Responses to FCC questions

Re: FCC ID EW780-5348-00

Correspondence Reference Number : 25368

Base Transmit Duty Cycle Calculation for SAR Measurement (Response item 8)

1.1 Frame Length

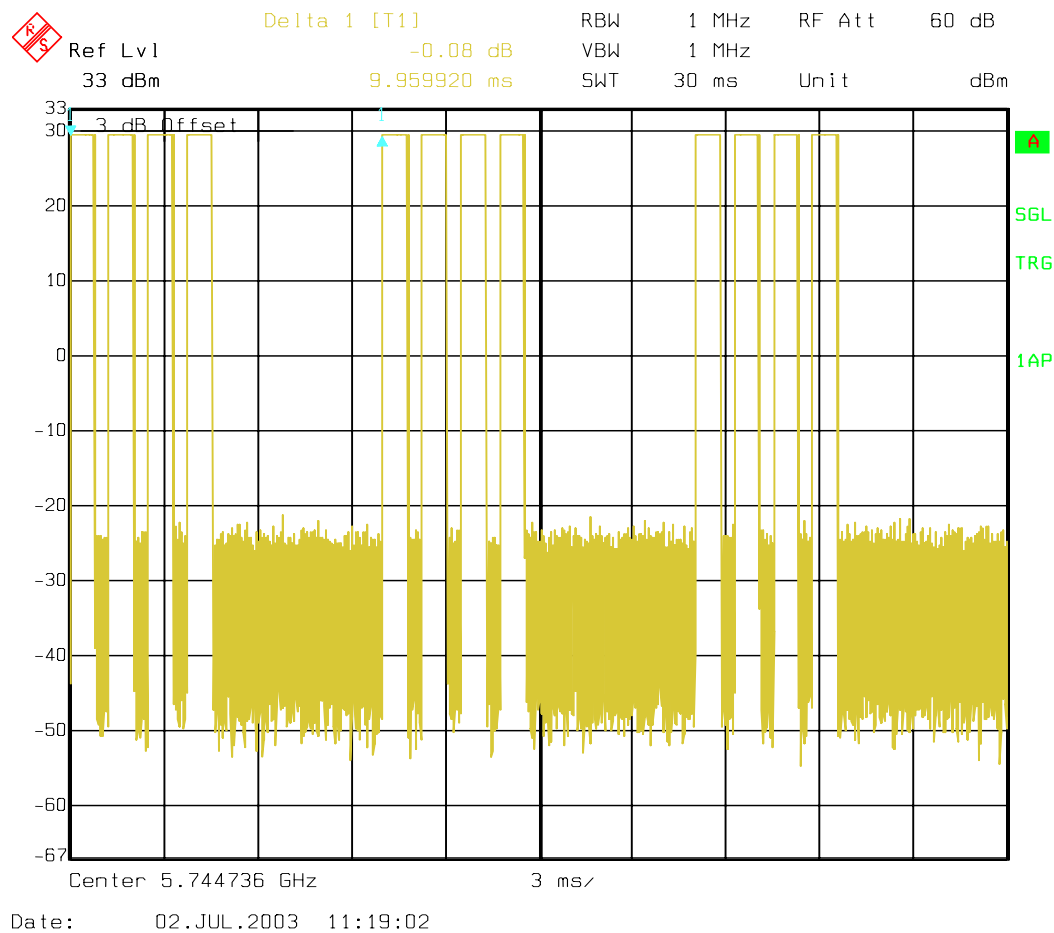
This test is done on a BS transmitter, set into Test Mode with all (4) tx slots active. Note that this is the heaviest the BS transmitter will be used during standard phone operation.

This plot shows the frame length as indicated by the markers: 9.96ms.
